## ADDENDUM

**ADDENDUM NO.:** 04  
**PROJECT NAME:** Emergency Medical Services (EMS) Addition  
**PROJECT NO.:** 07215  
**CONTRACT NO.:** C1611  
**DATE OF ISSUE:** July 31, 2024

### NOTICE OF CHANGES, MODIFICATIONS, OR CLARIFICATIONS TO CONTRACT DOCUMENTS

SHEET NUMBER: T502

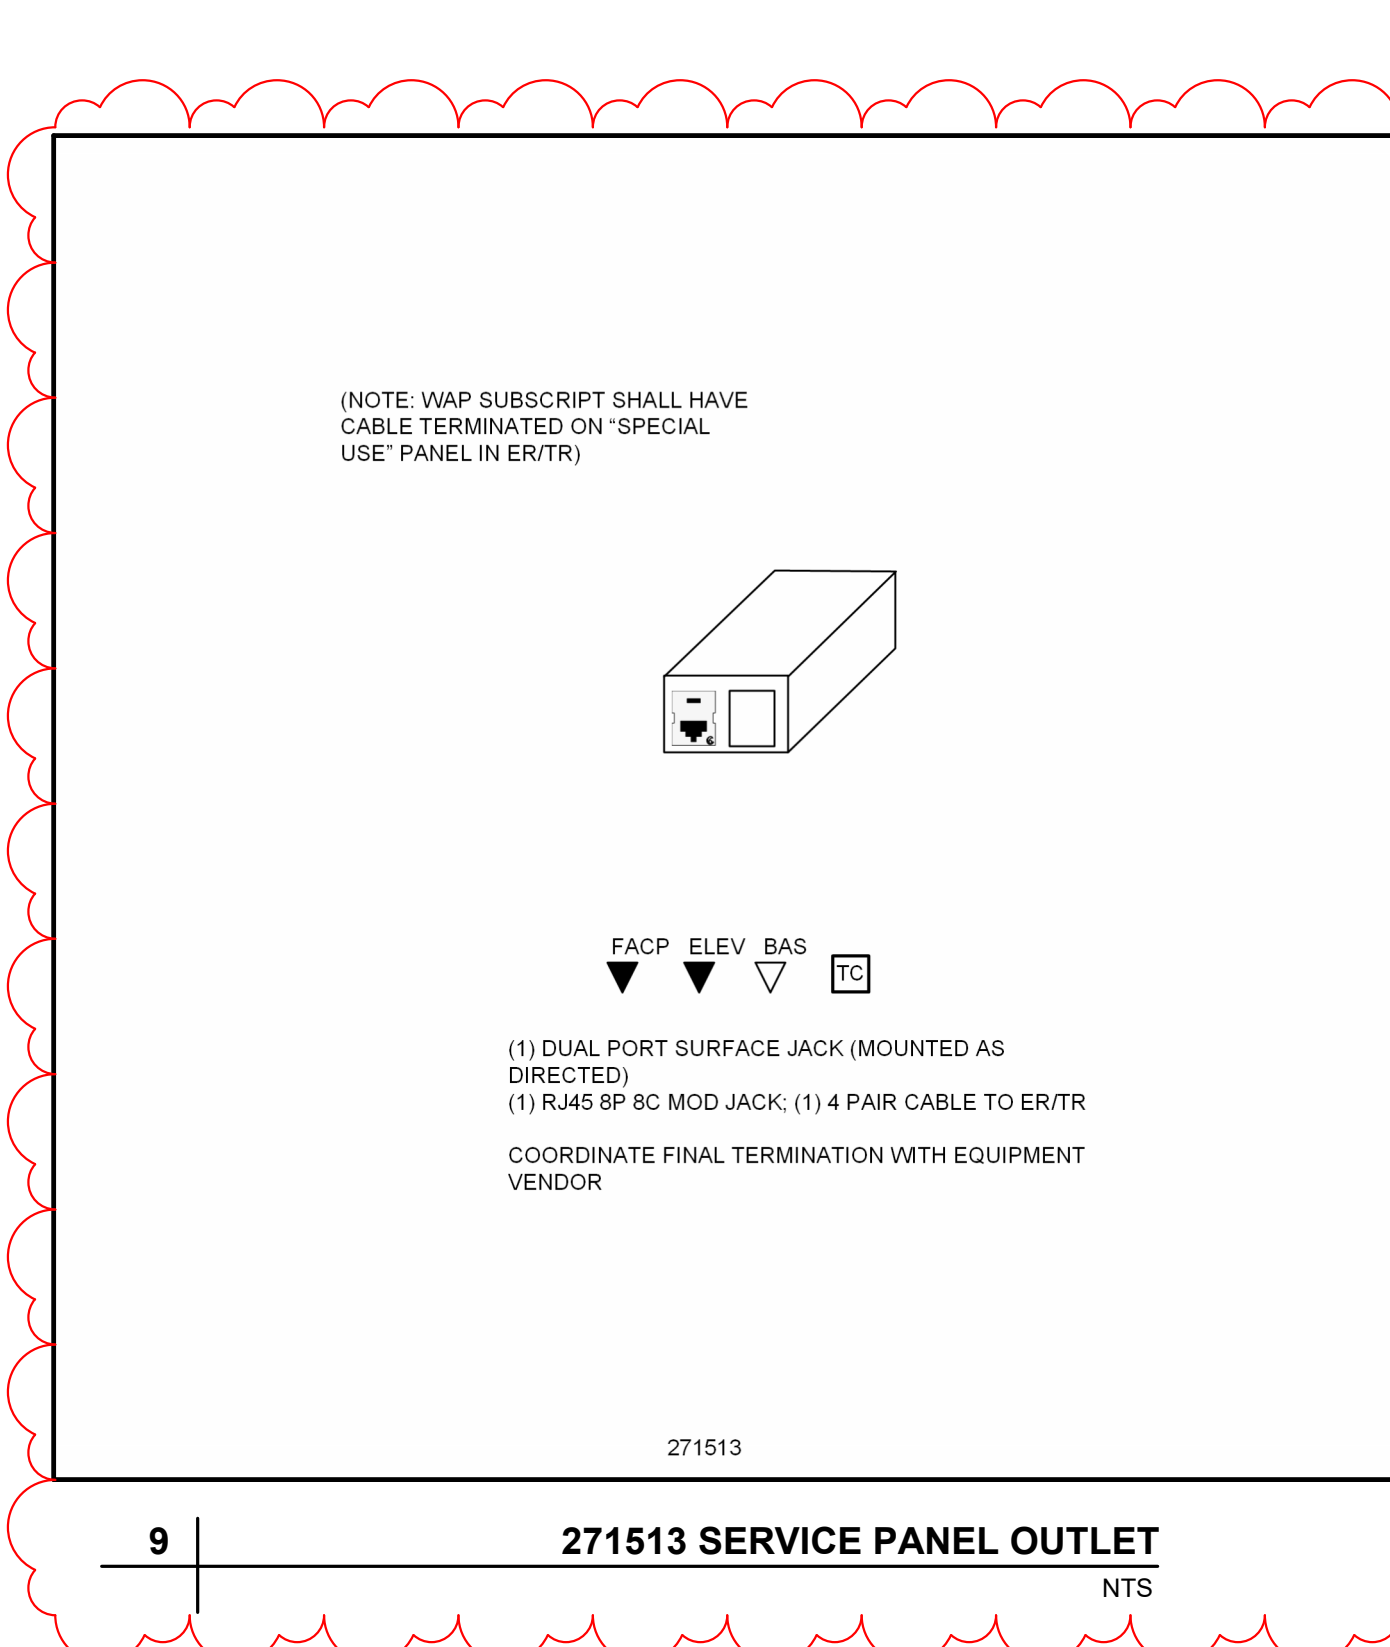
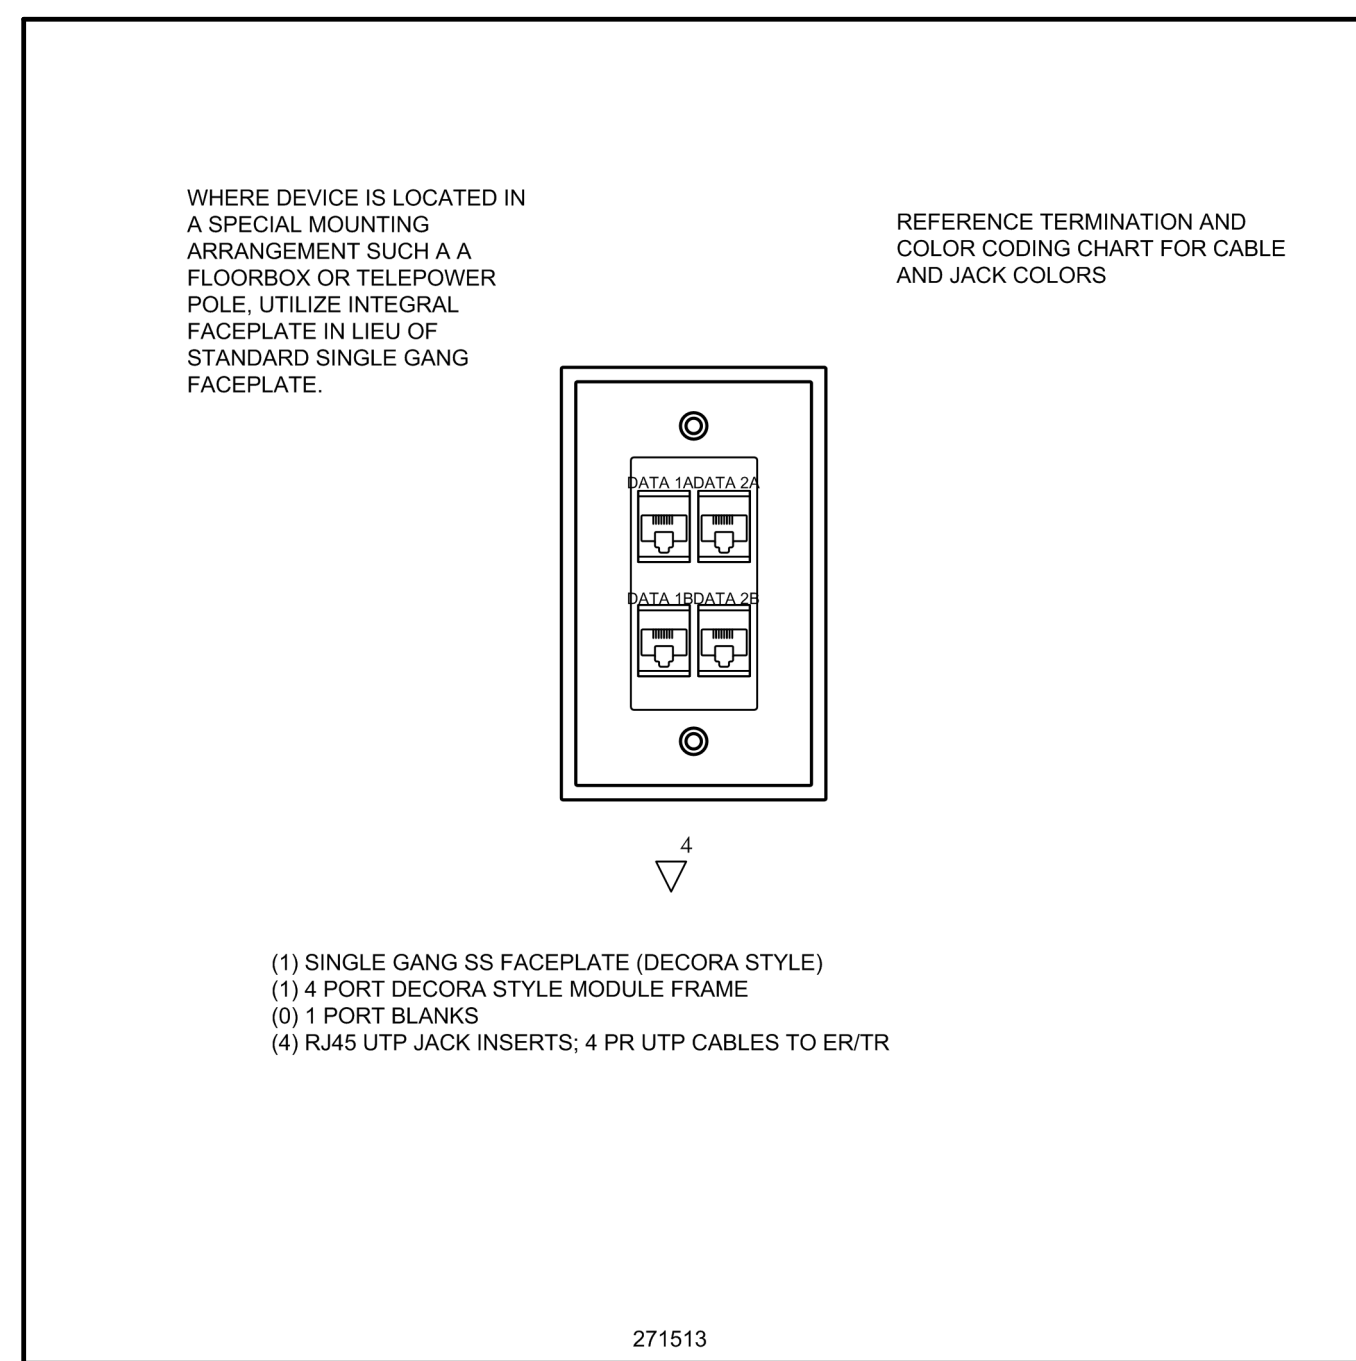
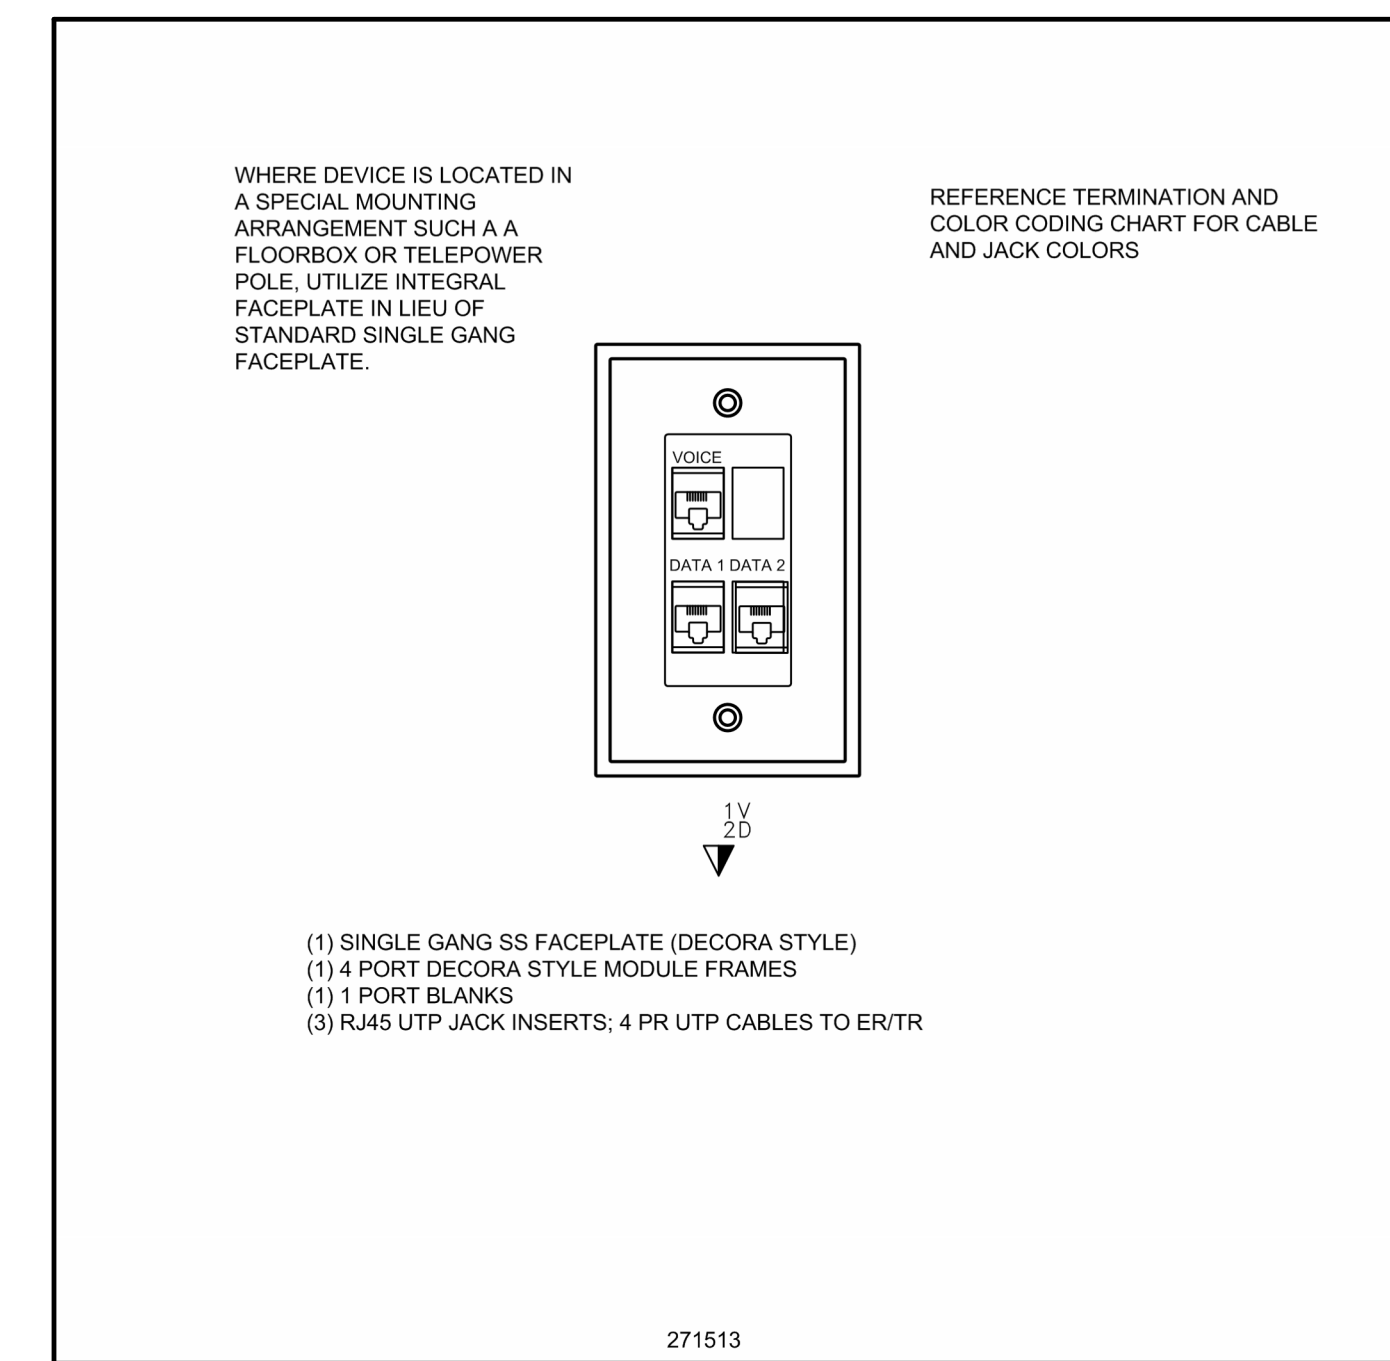
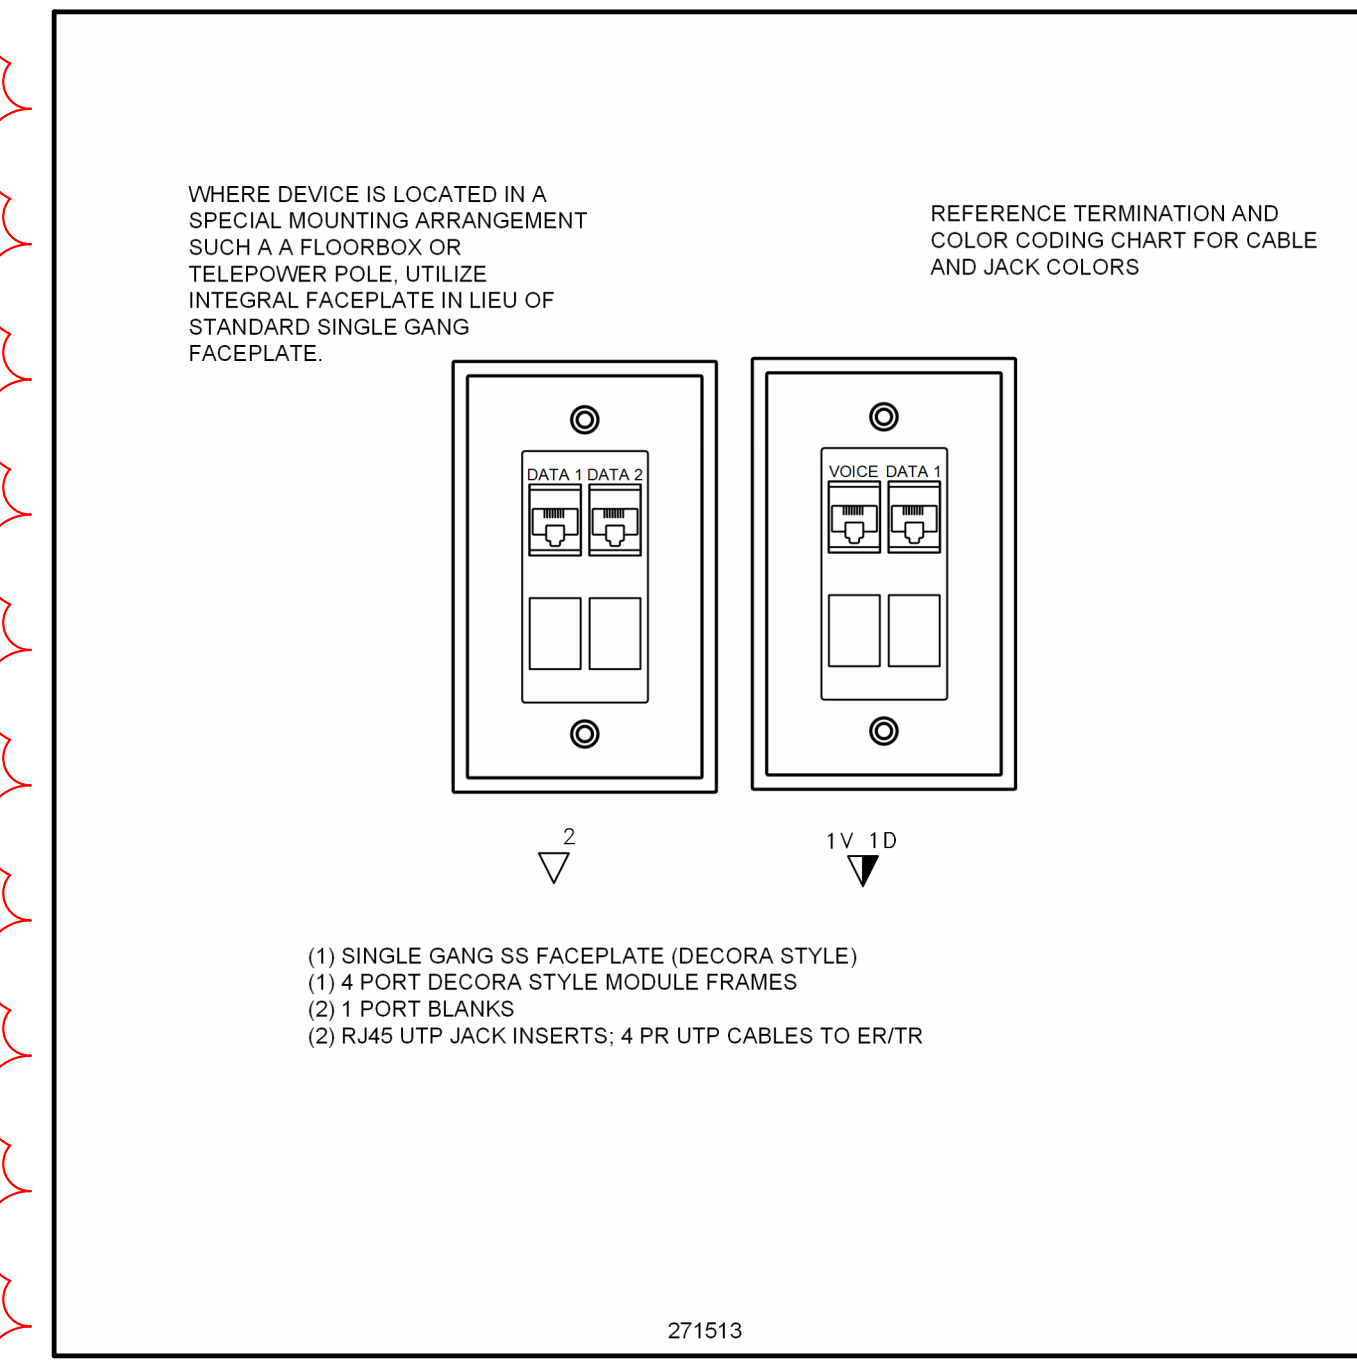
- Change 32** **REVISED** Drawing Nos. T110, T120 & T130 – Re-positioned/added Voice/Data outlets, changed AV equipment and updated room types.
- Change 33** **REVISED** Drawing No. T502 – Updated Details 4 & 9.
